UNITED STATES PATENT AND TRADEMARK OFFICE

APPLICATION NO.	FILING DATE	FIRST NAMED INVENTOR	ATTORNEY DOCKET NO.	CONFIRMATION NO.
10/072,990	02/12/2002	Nigel T. Birch	84572	3516

Office Action Summary

The following title is suggested: --A Gas Turbine Engine Exhaust Nozzle Having A Noise Attenuation Device Driven By Shape Memory Material Actuators--.

FIG. 1

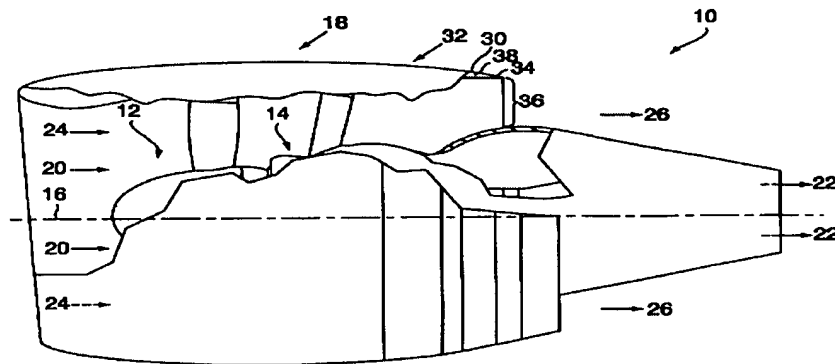
- ➔ 18. With respect to claim 1, **Rey et al.** teach a gas turbine engine exhaust nozzle arrangement for the flow of exhaust gases therethrough between an upstream end and a downstream end thereof comprising a nozzle, a downstream portion and a plurality of tabs 38, each tab 38 extends in a generally axial direction from the downstream portion of the nozzle wherein the nozzle further comprises an actuation mechanism capable of moving the tabs between a first deployed position, in the first position the tabs interact with a gas stream to reduce exhaust noise thereof, and a second non-deployed position, in the second position the tabs are substantially aerodynamically unobtrusive. See particularly **Figures 1 and 2 of Rey et al.**

- ✓ 30. With respect to claims 48-50, **Rey et al.** teach that exhaust nozzle arrangement comprises a core exhaust nozzle and a bypass exhaust nozzle. See particularly **Figure 1** of Rey et al.
- ✓ 31. With respect to claim 53, **Rey et al.** teach that the downstream end of the bypass nozzle is upstream of the downstream periphery of the core exhaust nozzle. See particularly **Figure 1** of Rey et al.
- ✓ 32. With respect to claim 55, **Rey et al.** teach that the tabs extend generally in a downstream direction. See particularly **Figure 2** of Rey et al.
- 33. With respect to claim 57, the operation of the prior art apparatus of **Rey et al.** will inherently perform the claimed method.

FIG. 2

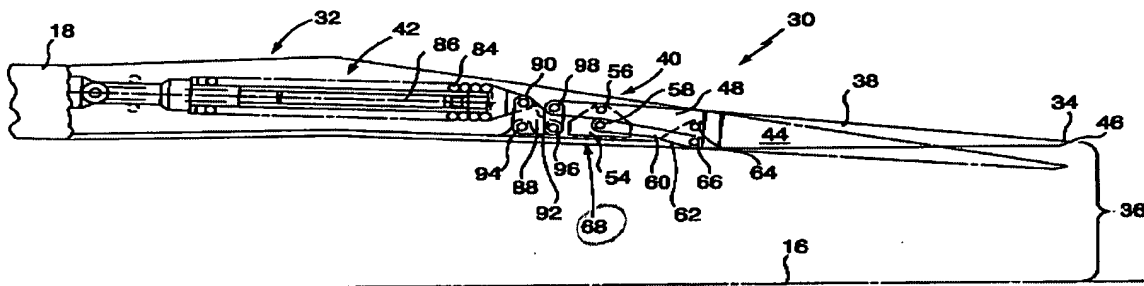
- ✓ 19. With respect to claim 2, **Rey et al.** teach that the plurality of tabs 38 are circumferentially disposed about the nozzle. See particularly **Figures 1 and 2 of Rey et al.**

20. With respect to claim 3, **Rey et al.** teach that the actuation mechanism comprises a shape memory material element 68. See particularly **Figure 2 of Rey et al.**

21. With respect to claim 5, **Rey et al.** teach that the periphery of the nozzle defines a pocket therein and at least a part of the element 68 is generally disposed within the pocket. See particularly **Figure 2 of Rey et al.**

- ✓ 27. With respect to claim 25, **Rey et al.** teach that the downstream portion of the nozzle comprises a downstream periphery, the plurality of circumferentially disposed tabs 38 extend in a generally downstream direction from the downstream periphery. See particularly **Figure 2** of **Rey et al.**
- ✓ 28. With respect to claim 30, **Rey et al.** teach that the tabs circumferentially taper in the downstream direction. See particularly **Figure 2** of **Rey et al.**
- ✓ 29. With respect to claims 41 and 43, **Rey et al.** teach that the taps 38 have a first shape in the deployed position and a second shape in the non-deployed position. In the deployed position, the first shape has a first length which is longer than a second length (when the tap is in the non-deployed position, second shape). See particularly **Figures 2, 3, 9 and 10** of **Rey et al.**

FIG. 6

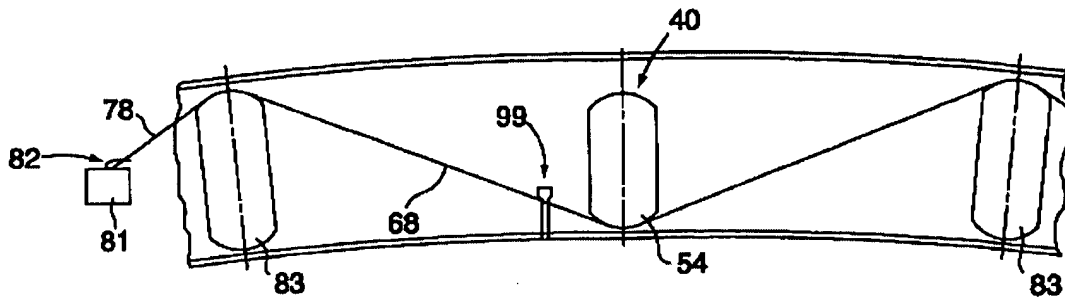
26. With respect to claims 19-21, **Rey et al.** teach that to actuate the taps 38, the control system 81 applies heat or voltage across the SMA material to heat the SMA actuator. See particularly **Figure 6 of Rey et al.**
